ADDENDUM NO.3 TO PROJECT NO. 44300

**CONSTRUCTION WORK
REPLACE WINDOWS,
CHAPEL/EDUCATION BLDG 13, GYMNASIUM BLDG 15 AND
WORK RELEASE HOUSING BLDG 12
FISHKILL CORRECTIONAL FACILITY
PROSPECT STREET
BEACON, NY 12508**

August 28, 2012

DRAWING NUMBER:
SK-1

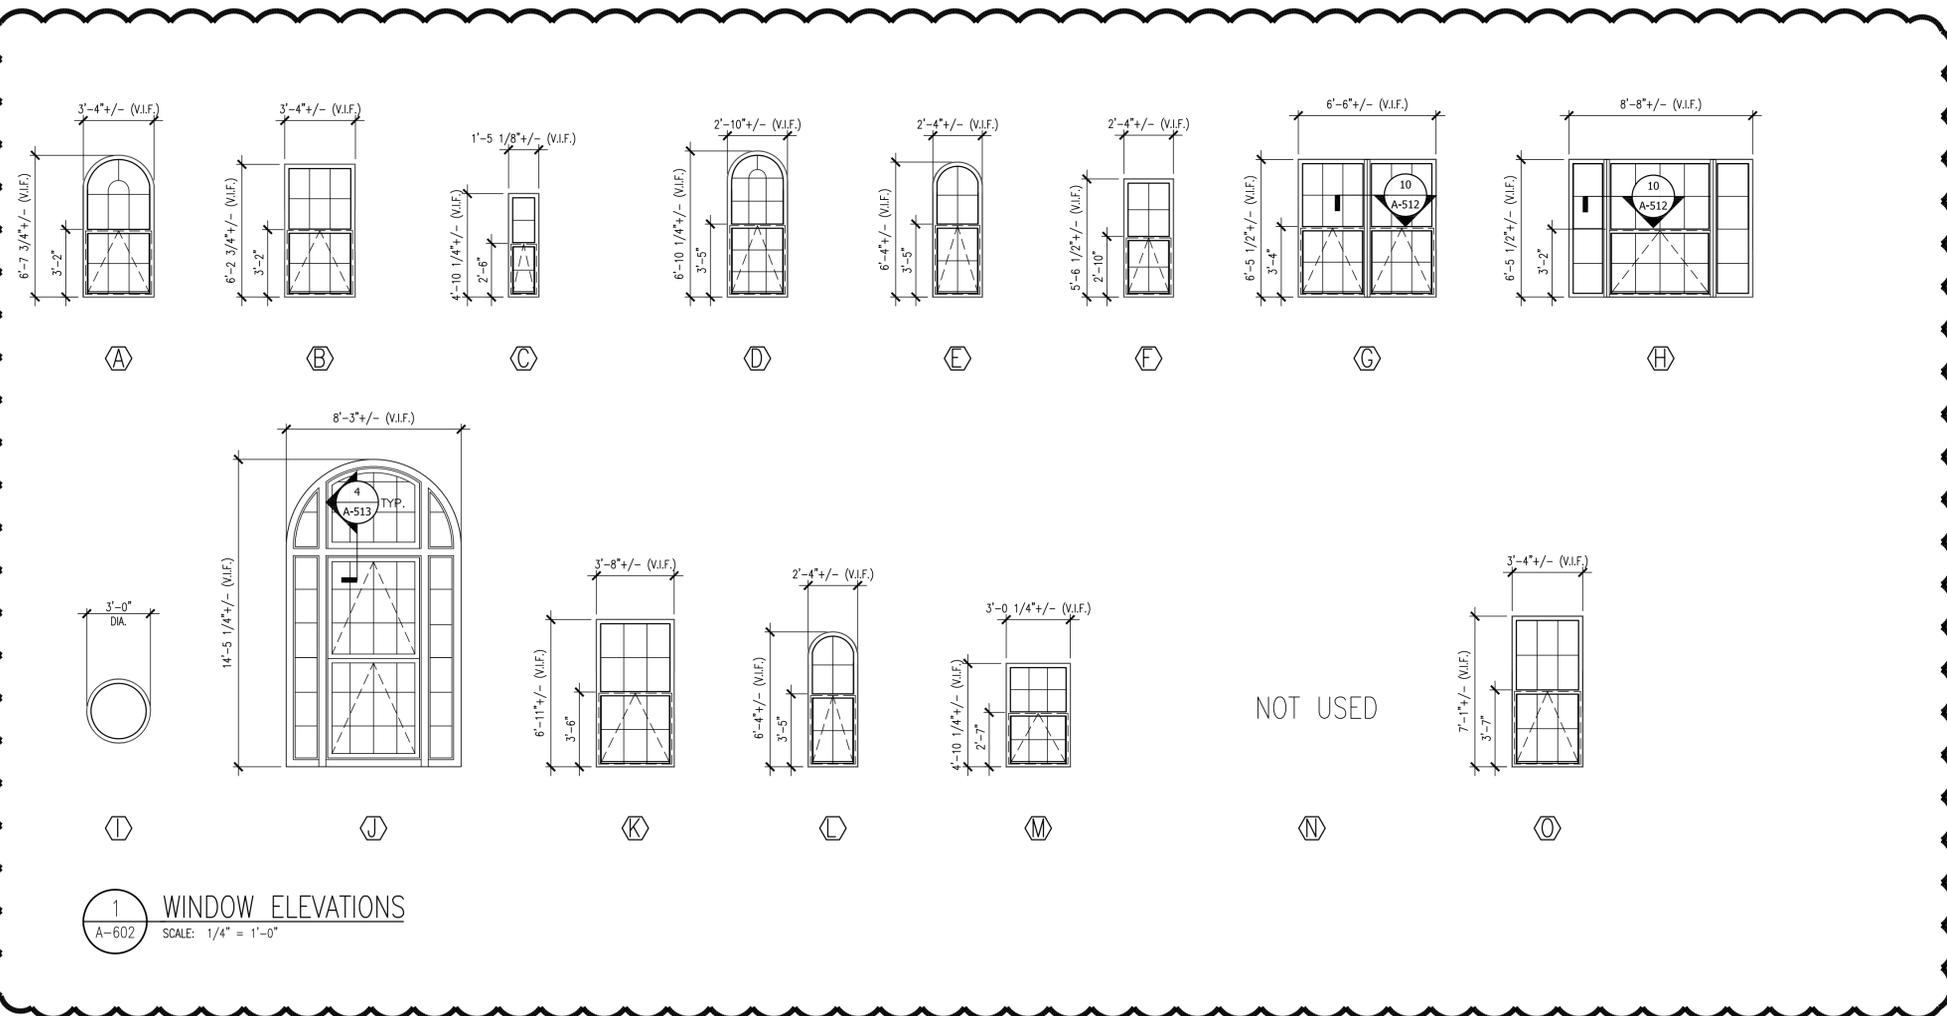
- a. 1/A-602 Window Elevations: Replace window elevations with attached drawing SK-1, Provide steel T muntins as shown.

1
SK-2

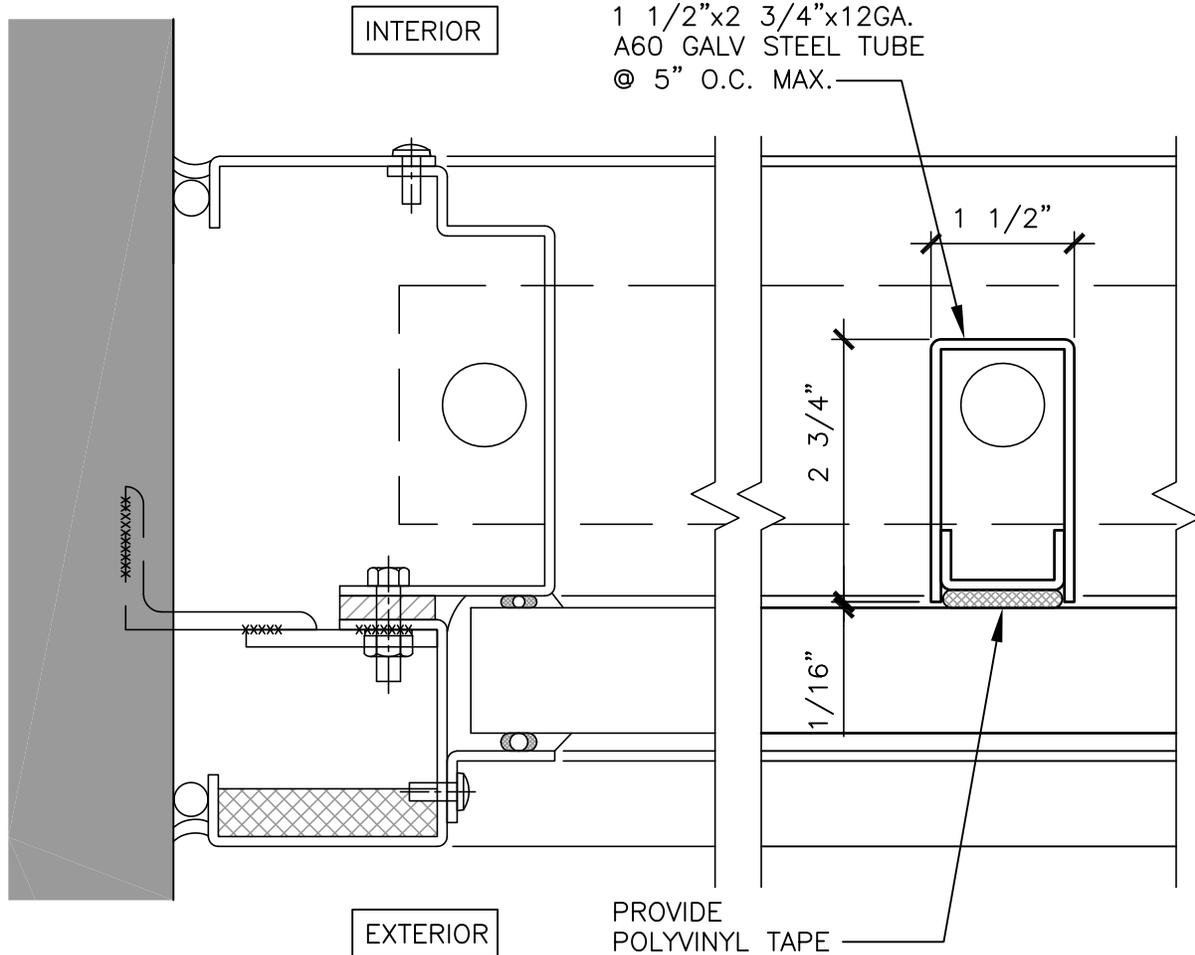
- a. Add to notes: “Window manufacturer to provide closure between tool resistant bars and fixed glass in the type 3 windows as required to eliminate gaps between the bars and the glass.”
- b. Add plan detail 1/SK-2 – TWO PIECE TUBE to security bars on the type 3 windows:
See attached drawing SK-2.

THE GAP BETWEEN THE TOOL RESISTANT BARS AND FIXED GLASS IN THE TYPE 3 WINDOWS, TWO PIECE TUBE IS TO BE INSTALLED TIGHT AGAINST THE GLASS, ELIMINATING THE GAP BETWEEN THE BARS AND THE FIXED GLASS.
